EXHIBIT 3 - STAFF REPORT

DATE: January 5, 2021
TO: Historic Landmark Committee Members
FROM: Chuck Darnell, Senior Planner
SUBJECT: PUBLIC MEETING: HL 7-20 (Certificate of Approval for Alteration) –
608 NE 3rd Street

Figure 2. Elevations

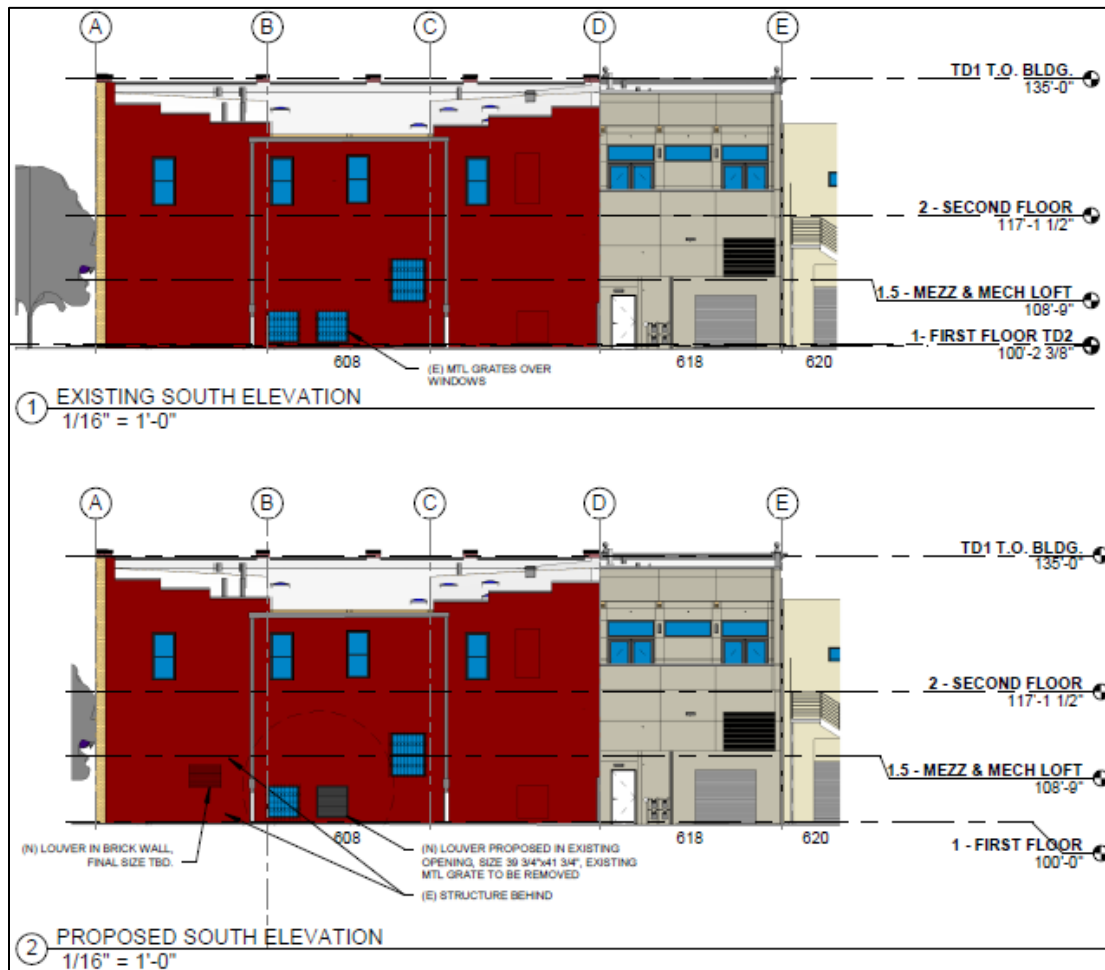
The applicant has provided elevations and illustrations identifying the improvements that would occur, should the Certificate of Approval for Alteration land-use application be approved. See Elevations (Figure 2) below.

Overall, the alterations that are proposed do not impact the overall character-defining structural components of the historic landmark. The proposal focuses the alterations on the rear (alley/south) façade of the building, which avoids any impact to the more character-defining features and characteristics of the historic landmark. These features are more specifically described in the Historic Resources Inventory and would remain intact, including the brick façade and brick detailing (cornice, belt courses, and piers), storefront window and entrances, and windows on the north and west facades. Some Committee members will remember that these features were preserved or replaced, as approved, during past rehabilitation work on the building that was reviewed and approved by the City's Historic Landmarks Committee under past Certificate of Approval and Downtown Design applications.

The addition of the two louvers on the rear façade is being proposed to accommodate a new use within the building, and are necessary to the functioning of that use. The louvers will provide ventilation and return air for a commercial hood to support the kitchen for a restaurant within the building. The applicant has provided findings and arguments for the need for these louvers, and has proposed a method of installation that avoids impacts to the most historically significant features of the building. The louvers are proposed to be installed in the rear façade, which faces south and toward the alley. This rear (alley/south) façade is not as historically significant as the north and west building facades. The south (alley) facade was replaced with a stucco finish that is not historic to the building and is not a prominent building elevation since it fronts on the alley. Therefore, the addition of the required ventilation in this

The proposal does include the creation of one new opening in this rear (alley/south) façade for one new louver, and the removal of glazing within one existing window opening to allow for the second louver. While these will alter the existing building façade, staff agrees with the applicant in that the installation of the louvers in this location would be least disruptive or impactful to the historic character of the building. The louvers, and the new opening in the building wall, will occur on the rear façade that has already been altered from its historic form and materials with a more modern stucco finish that is not historic to the building (which occurred prior to the current owners controlling the building and also occurred at a time when that type of work did not meet the City's definition of an alteration to a historic landmark (this definition has since been updated)).

The window that is being replaced with the other louver is not a window that contributes greatly to the historic character of the building, as it is within the rear (alley/south) building façade that is not as historically significant as described in more detail above. The alternative to the removal of this window would be to direct the ventilation ductwork to another area in the rear façade, which would result in an additional opening in the building wall, or to direct the ventilation ductwork to either the west or north building facades which would impact more character-defining features of the building. Staff believes that the addition of the louver either within the brick façade or within another existing window on the west or north façades would have more negative impacts on the historic character of the building than the location as proposed on the rear (alley/south) façade.

The applicant is also proposing to install the new louvers in a manner that would blend into the existing wall and be as visually compatible with the exterior of the building as possible. The louvers will be painted to match either the color of the surrounding stucco or the window, as applicable. In addition, the proposed construction of the louver in the window opening, as shown in the details provided on Sheet SD-4, would allow for the louver be removed in the future and the window re-established, should the internal use of the building no longer require the ventilation provided by the louver. If the Historic Landmarks Committee finds that the Certificate of Approval application meets the applicable review criteria and should be approved, staff is suggesting that a condition of approval be included to verify that the louvers be installed as shown in the construction details within the application materials.

1. That the louvers shall be finished as proposed in the application narrative and application materials. Specifically, the louver that will be in a new opening in the building façade shall be constructed as identified on Sheet SD-5 and shall be painted to match the color of the surrounding stucco on the building façade. The louver that will be in the existing window opening shall be constructed as identified on Sheet SD-4 and will be painted to match the color of the remaining windows on the south building façade.
